Core Operating Limits Report

Dresden Station Unit 2

Cycle 12

Revision 1

Figure 5.2-1
MCPR Limit vs. Measured Scram Time to 90% Insertion
Rated Flow Conditions

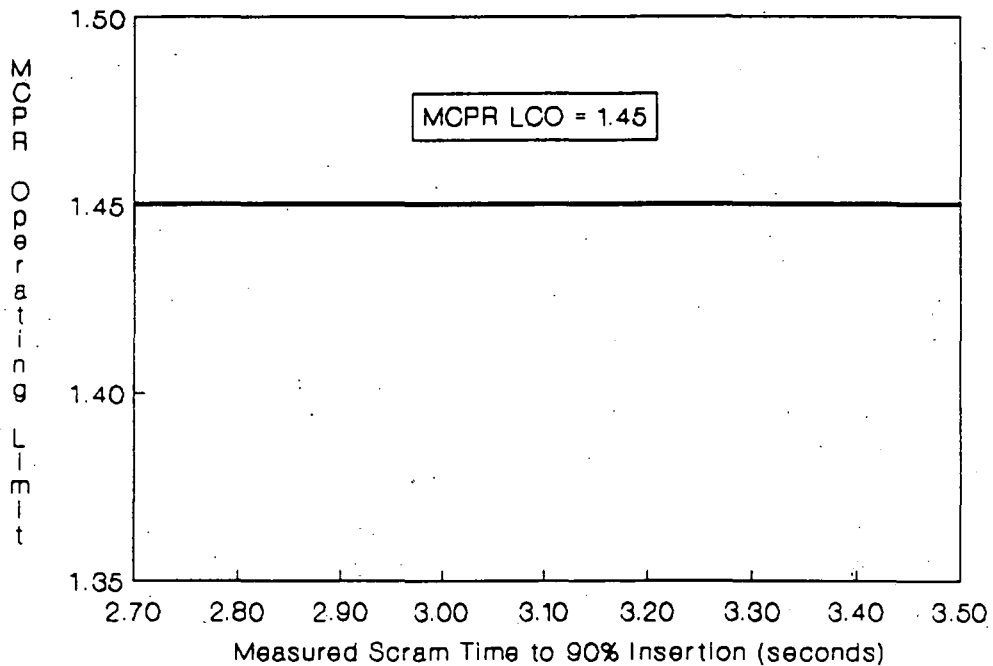
- a. The MCPR Operating Limit at rated flow versus measured scram time is shown in Figure 5.2-1. The MCPR Operating Limit is 1.45 or greater whenever the measured 90% insertion time is 3.50 seconds or less.
- b. During Manual Flow Control, the MCPR Operating Limit at reduced flow rates can be determined from:
 - i. Figure 5.2-2 using the appropriate flow rate, or
 - ii. The rated flow MCPR Operating Limit determined via Figure 5.2-1,
whichever is greater.
- c. During Automatic Flow Control, the MCPR Operating Limit at reduced flow rates can be determined from Figure 5.2-3 using the appropriate flow rate and rated flow MCPR Operating Limit, which is obtained from Figure 5.2-1. Linear interpolation between the curves on Figure 5.2-3 is permissible.

$$\begin{array}{cccccc} (\text{MCPR OL}) + (\text{CPR Bow Penalty}) - (\text{XN-3 Conservatism}) & = & (\text{New MCPR OL}) \\ 1.39 & & 0.15 & & 0.09 & & 1.45 \end{array}$$

$$\text{MCPR LCO} = 1.45$$

Figure 5.2-3
 MCPR Operating Limit for Automatic Flow Control

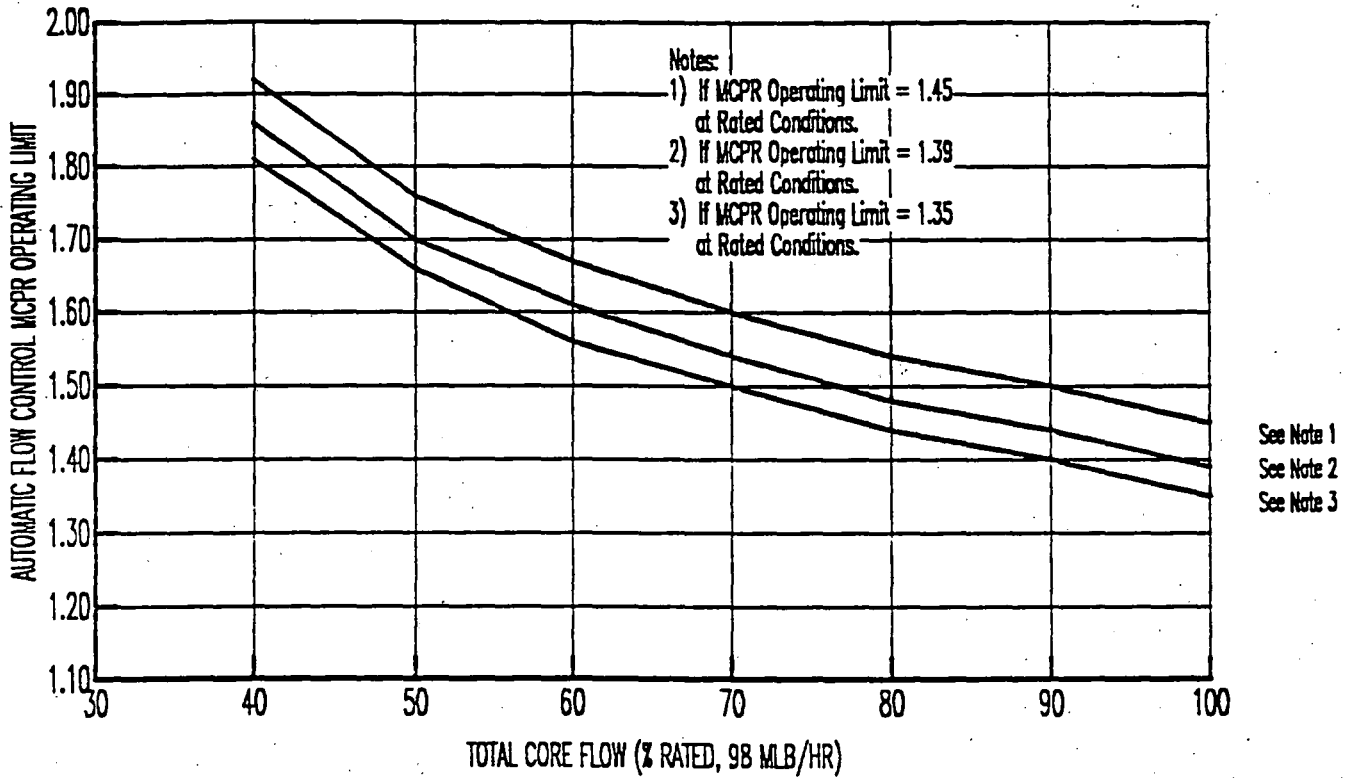
Revision 1 to the Dresden Unit 2 Cycle 12 COLR (Attachment 1) reflects this change in the full flow MCPR operating limit as well as the corresponding change to the reduced flow MCPR limits for Automatic Flow Control operation (COLR Figure 5.2-3).

Total Core Flow (% Rated)	MCPR Operating Limit*		
	1.35	1.39	1.45
100	1.35	1.39	1.45
90	1.40	1.44	1.50
80	1.44	1.48	1.54
70	1.50	1.54	1.60
60	1.56	1.61	1.67
50	1.66	1.70	1.76
40	1.81	1.86	1.92
